X-178 line

Eversource, please provide:

Figure 2. Noise map of baseline traffic volumes on Bear Lake Road and relative intensity of hiking use on adjacent trail network.

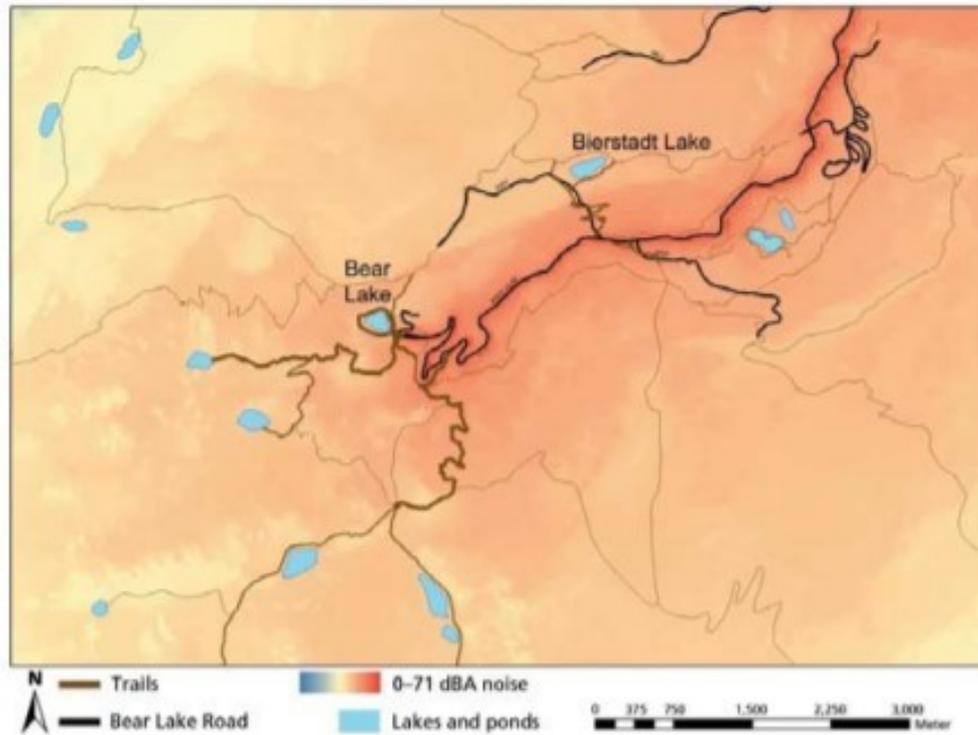
A noise-map for construction. An example is shown below:
